**Conditional Use Permit for Outdoor Storage – Lots 3
and 4 Brook Valley Corporate Park; 10946 Harry
Watanabe Parkway; Alff Construction, LLC**

**CITY OF LA VISTA
PLANNING DIVISION
RECOMMENDATION REPORT**

CASE NUMBERS: PRP24-0002;

RE: Brook Valley Corporate Park Planned Unit Development Amendment
ALFF Construction CUP
Initial Review Letter

AUTOTRACK DETAIL
NOT TO SCALE

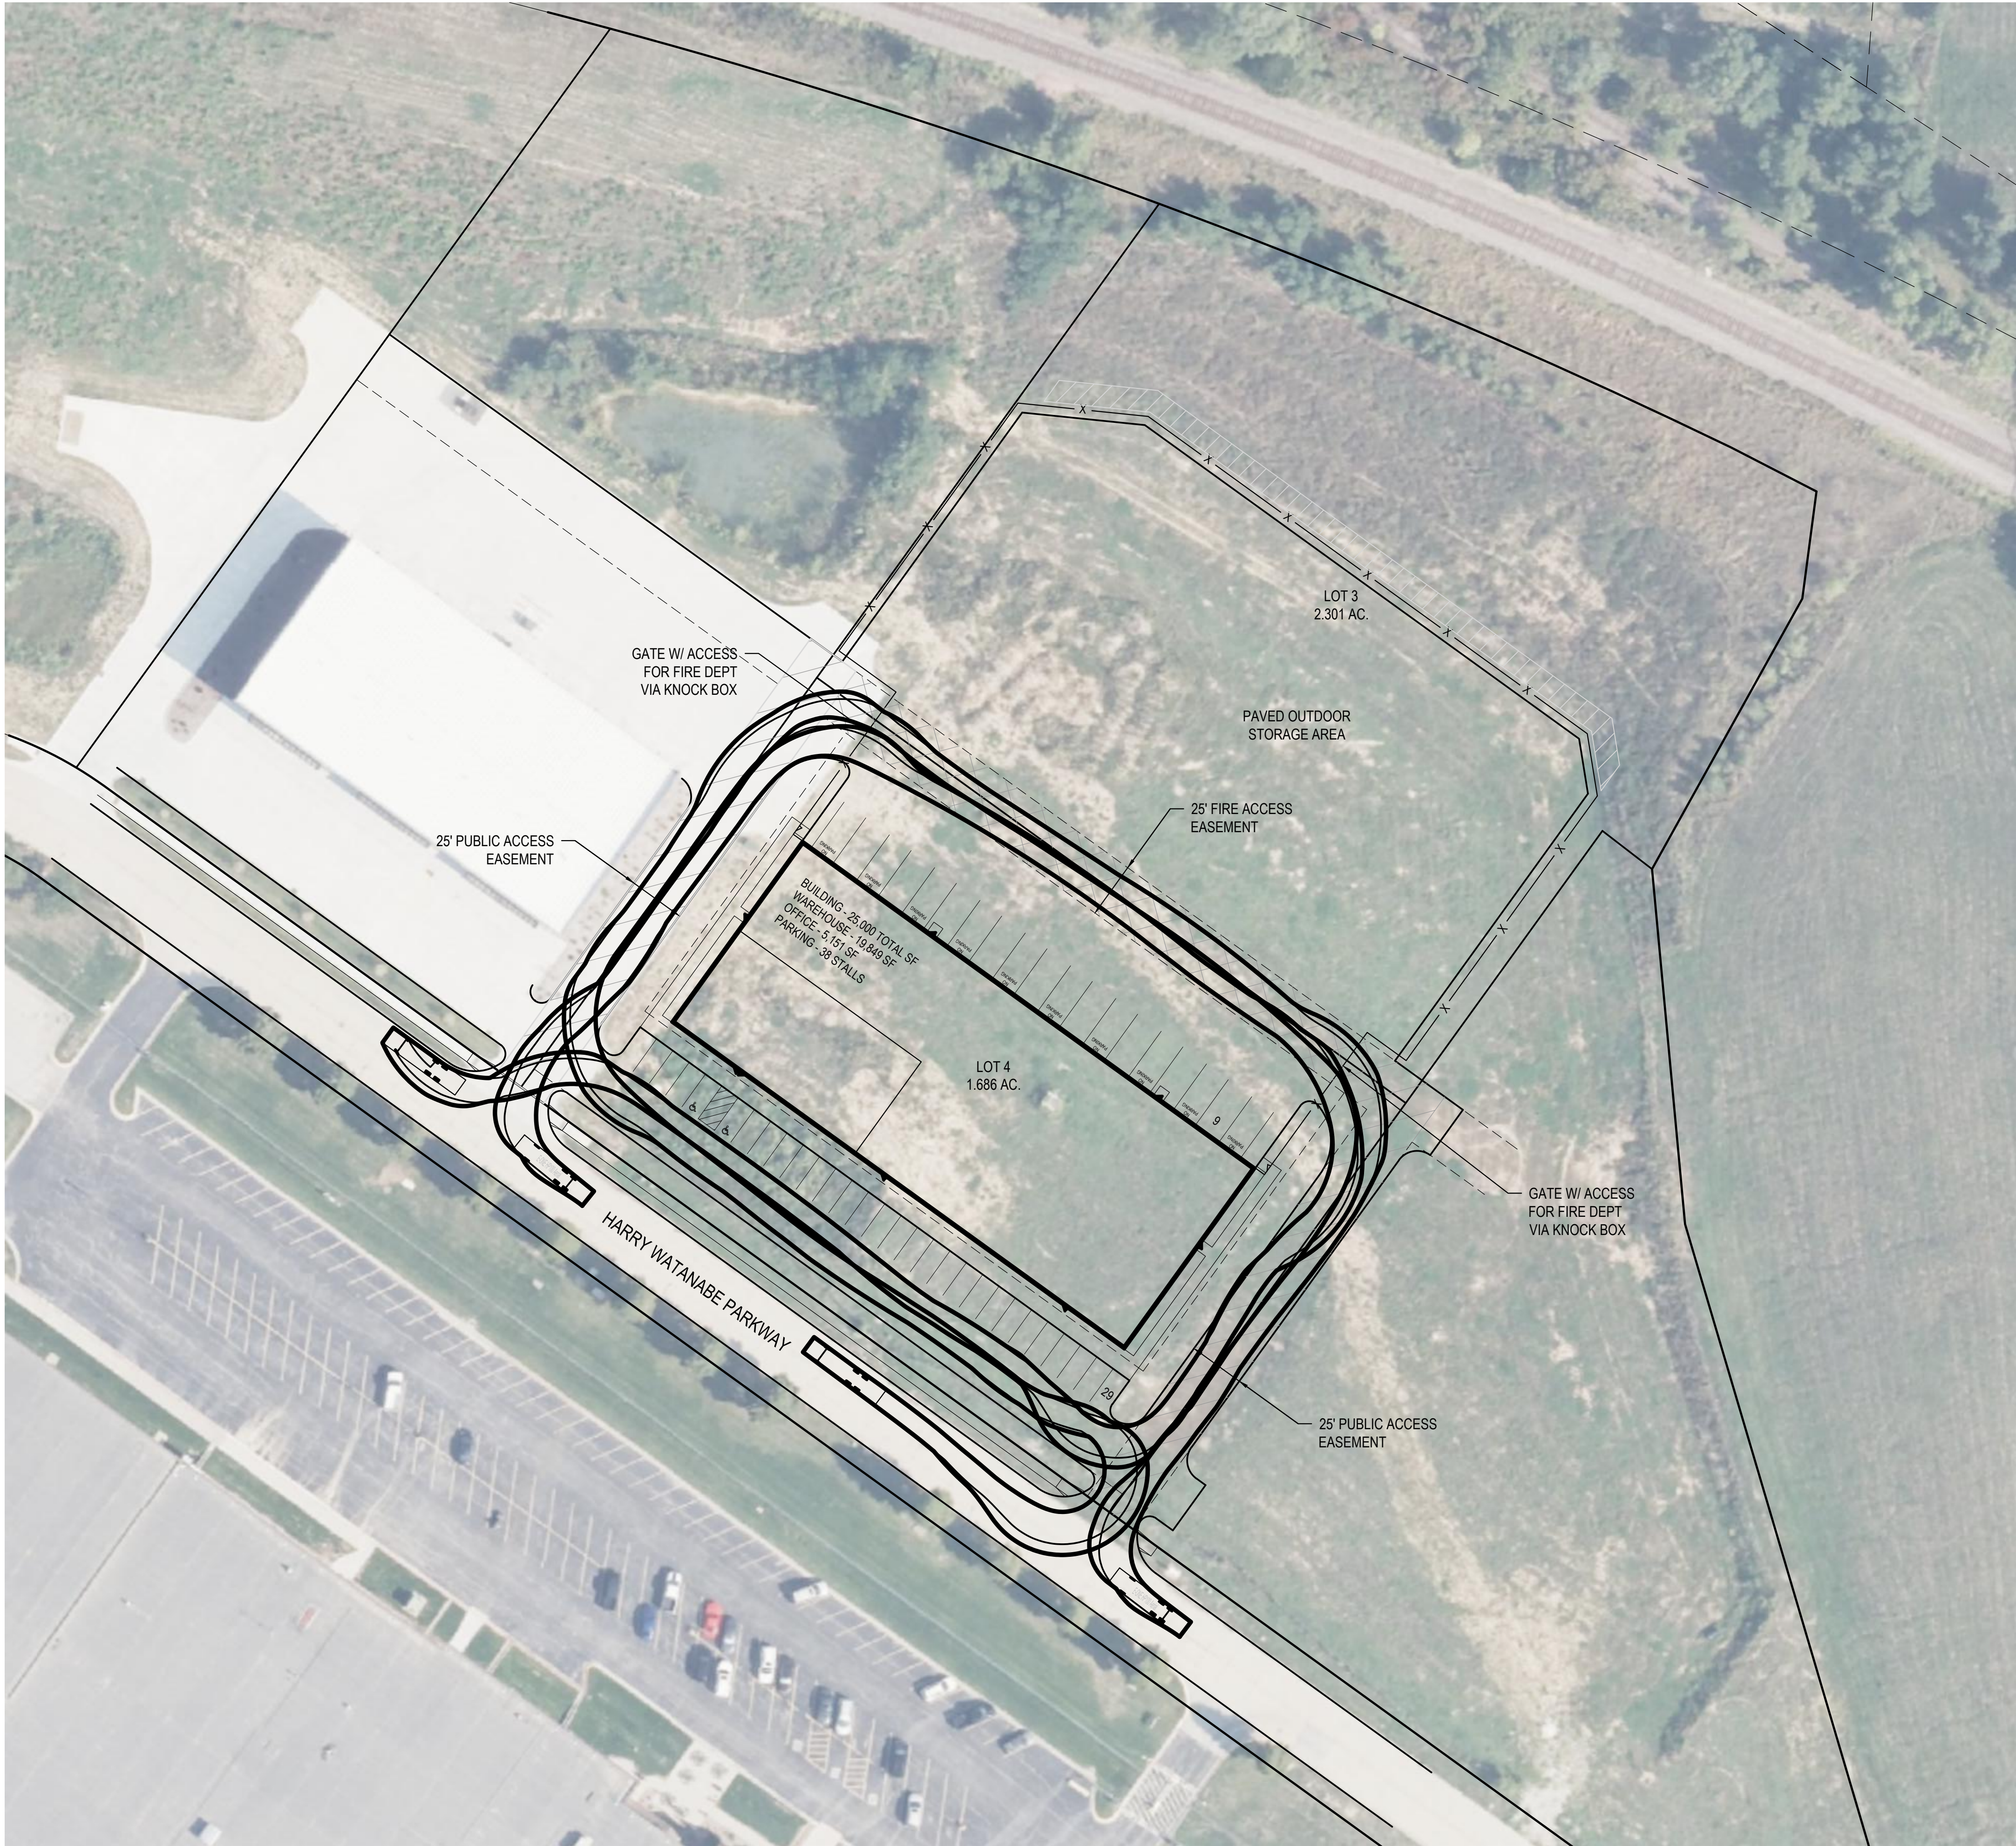
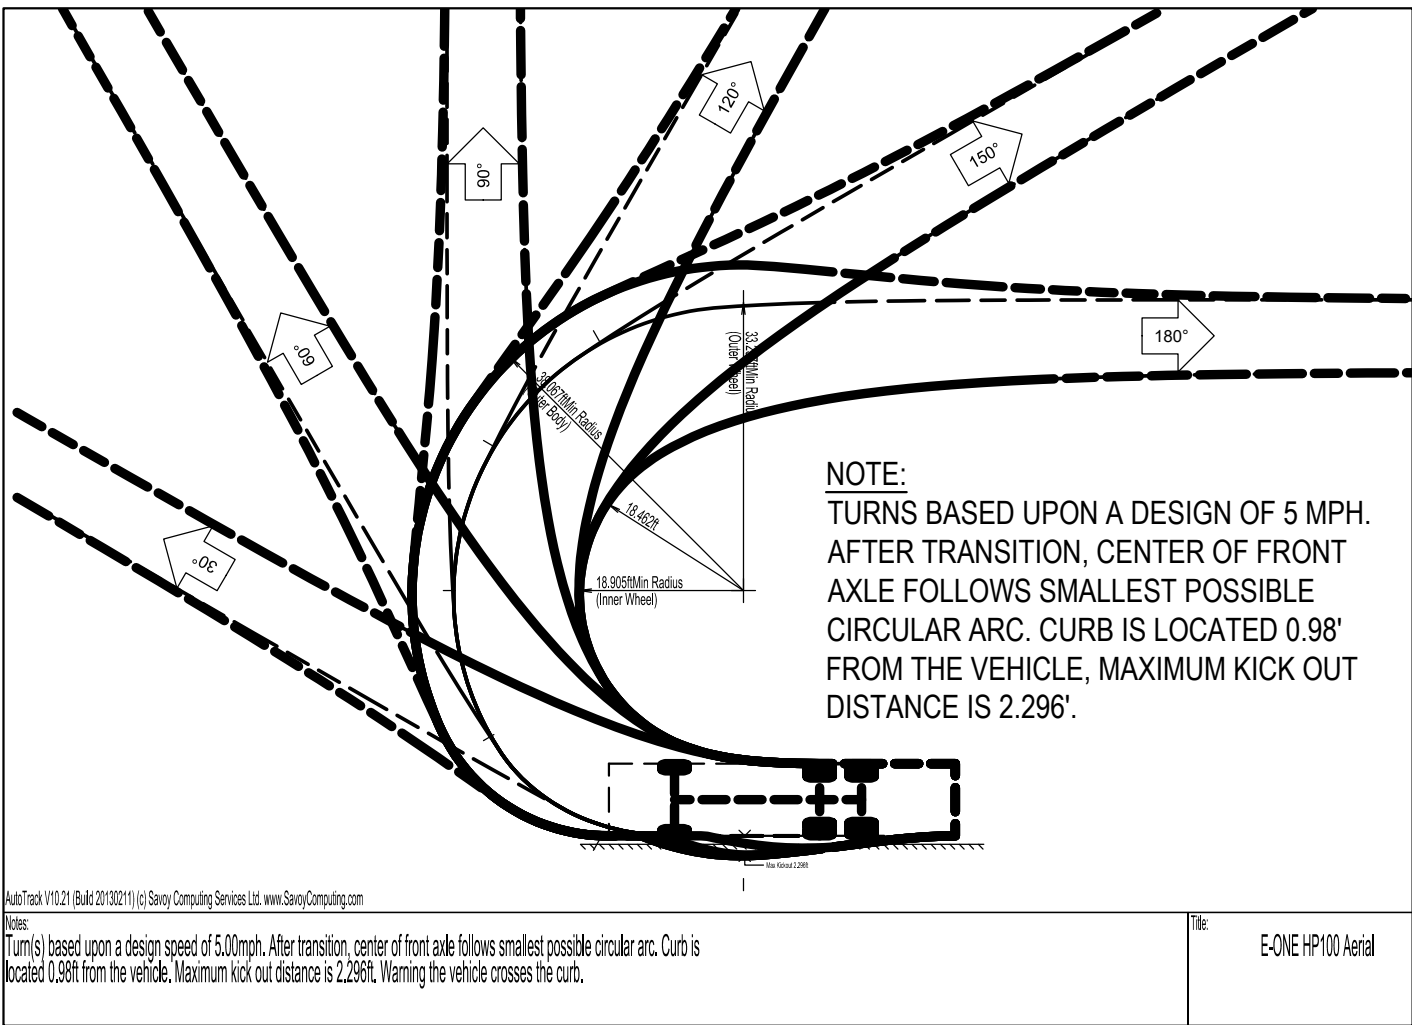
11. Per Section 5.15.05.08, the proposed Fire Easement was previously planned as a paved access route between the lots. Confirm the Fire Department is amenable to a gated fire easement and access gates.

5. Per 12/17/24 Comment # 11, approval by the Fire Department regarding the fire access route is critical to the viability of the proposed PUD. Approval needs to be obtained by the Fire Department prior to the application's review by City Council.

Response: We are continuing to coordinate with the La Vista Fire Department regarding gate access.
12. Per Section 7.17.03.02, the required landscape buffer along street frontage shall be 15', as opposed to the 10' you have shown. This can be reduced to 10' if an equal amount of square footage of landscaped area is provided elsewhere. If you wish to provide this additional landscaped area elsewhere, please identify this location and provide the calculation.

5. Per 1 2/17/24 Comment #11, approval by the Fire Department regarding the fire access route is critical to the viability of the proposed PUD. Approval needs to be obtained by the Fire Department prior to the application's review by City Council. *RESPONSE: La Vista Fire Department has confirmed that they are amenable to gated access with a knock box to provide access across the northern fire access route.*

TREE PLANTING DETAIL - B & B TREE
NOT TO SCALE

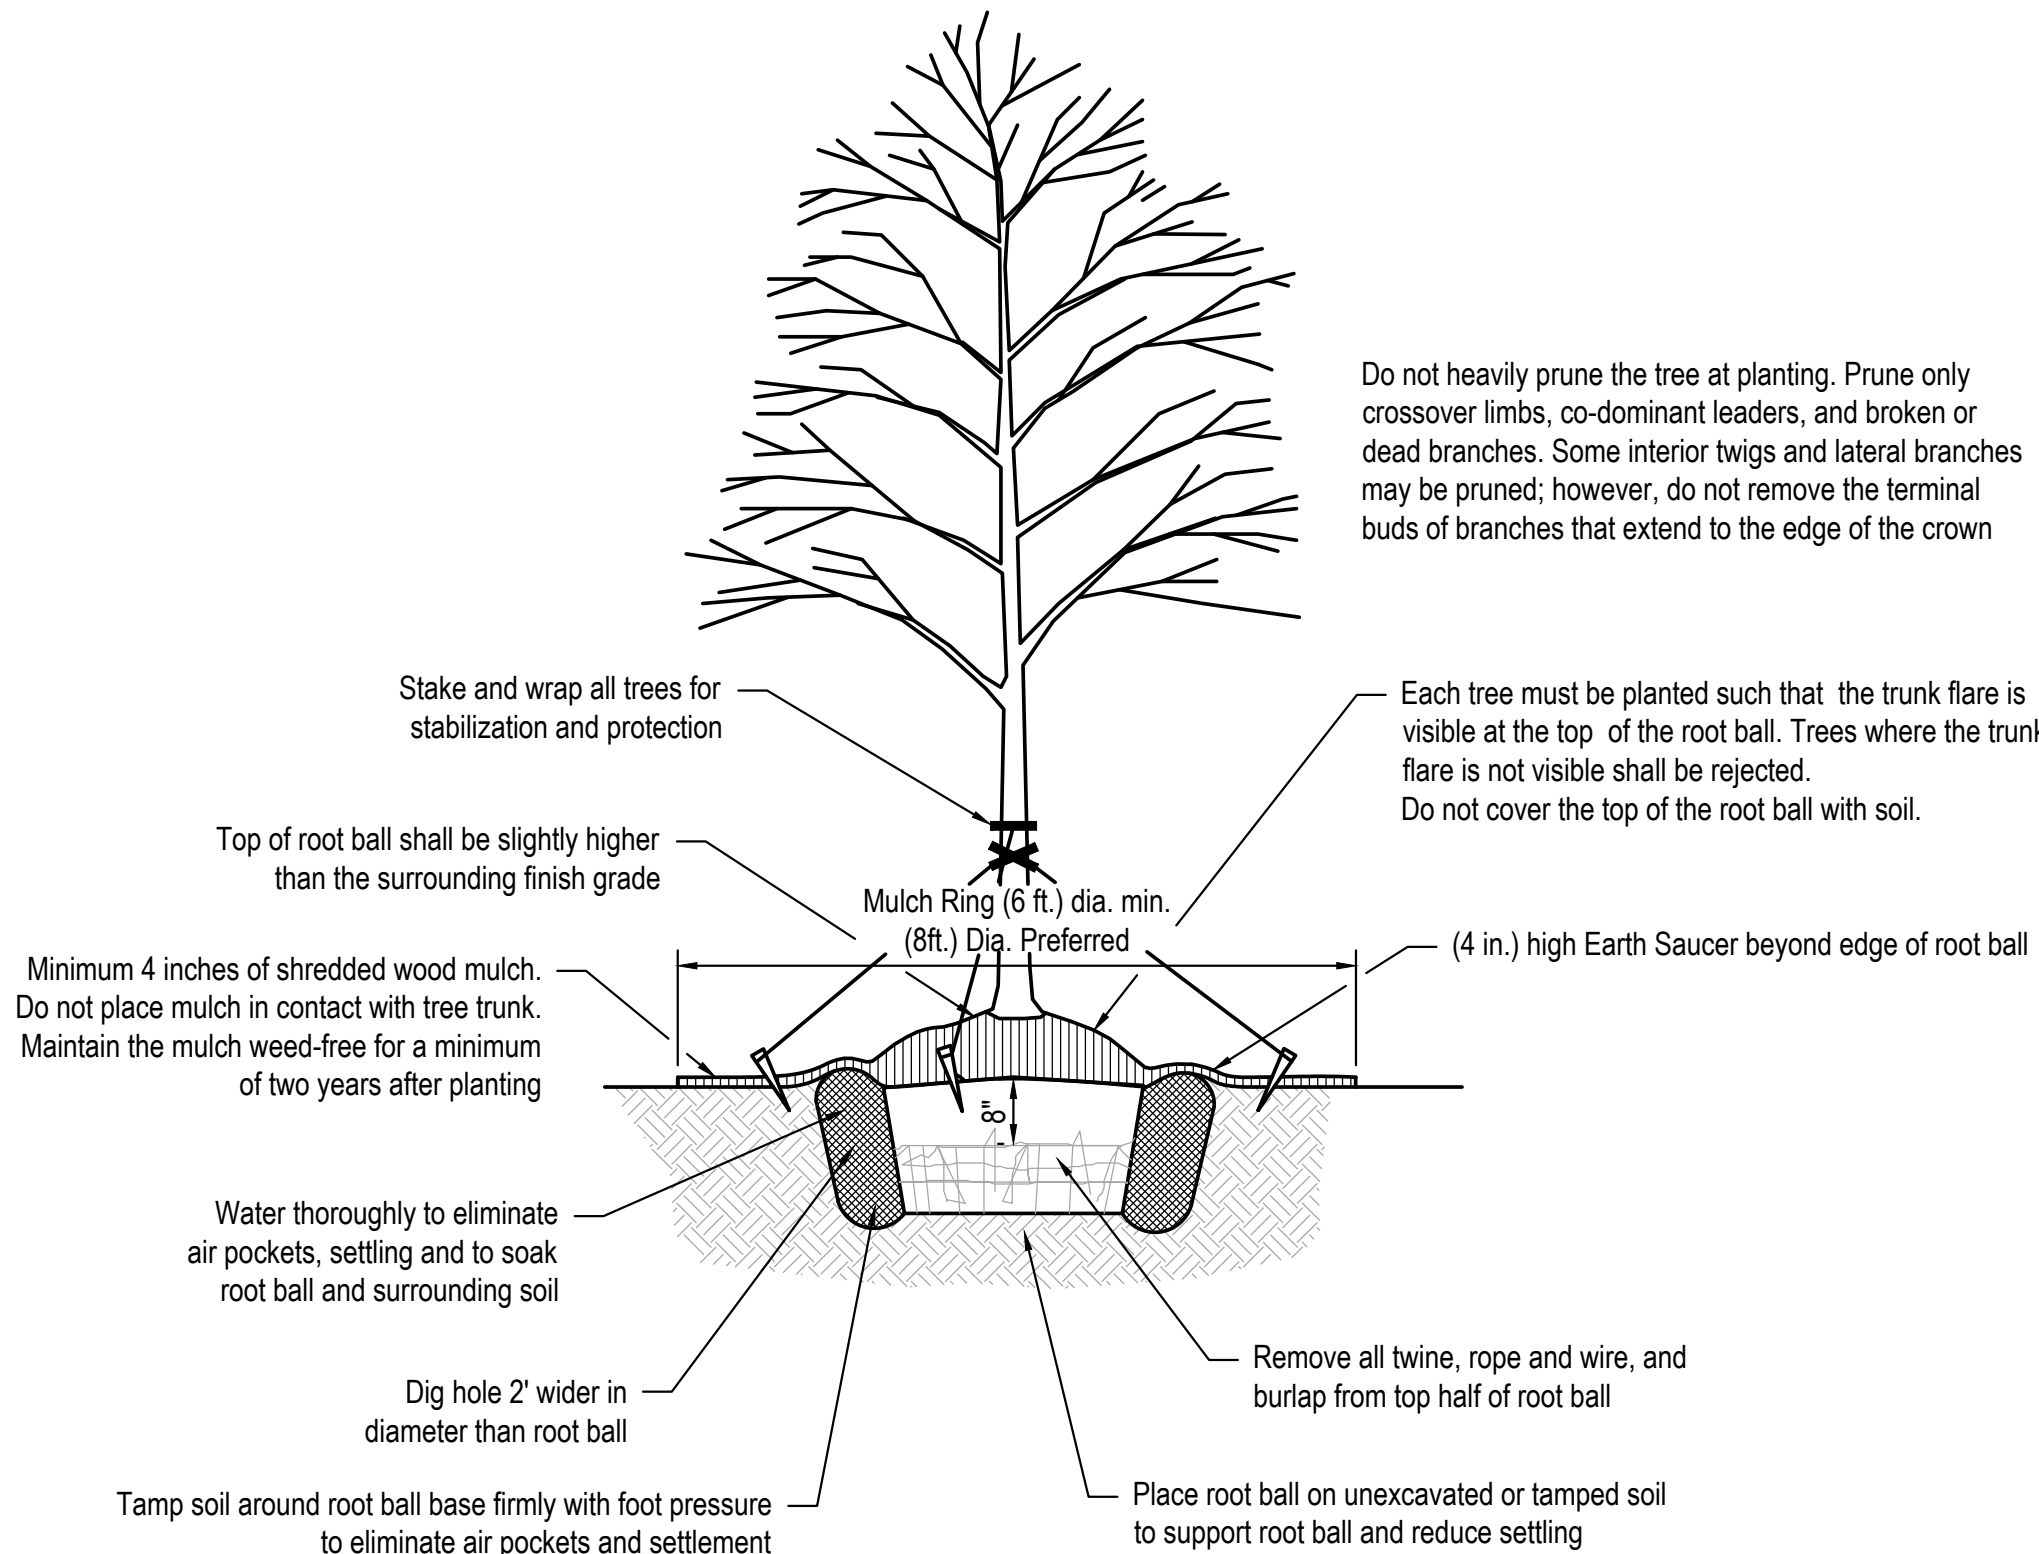
12. Per Section 7.17.03.02, the required landscape buffer along street frontage shall be 15', as opposed to the 10' you have shown. This can be reduced to 10' if an equal amount of square feet of landscaped area is provided elsewhere. If you wish to provide this additional landscaped area elsewhere, please identify this location and provide the calculation.

13. Per Section 7.17.03.02.3, a minimum of one tree shall be planted for every forty lineal feet or fraction thereof of street frontage. The current site plan shows 6 trees planted along Harry Watanabe Parkway. With 325 feet of frontage, 9 trees shall be planted.

Response: An additional landscaped area is being provided along the northeast fence to offset the front street yard landscape buffer per Section 7.17.03.02. Area calculations and hatching to denote the newly dedicated area have been added to the Landscape Plan. Please see the Landscape Plan for further details.

Response: We have added the required total of 9 trees to the front yard landscape buffer. Please see the updated PUD Landscape Plan.

- Areas to offset 5' reduction to Street Yard Landscape buffer per Section 7.17.03.02 - Area Required: 1,625 SF
- Area Provided: 3,172 SF
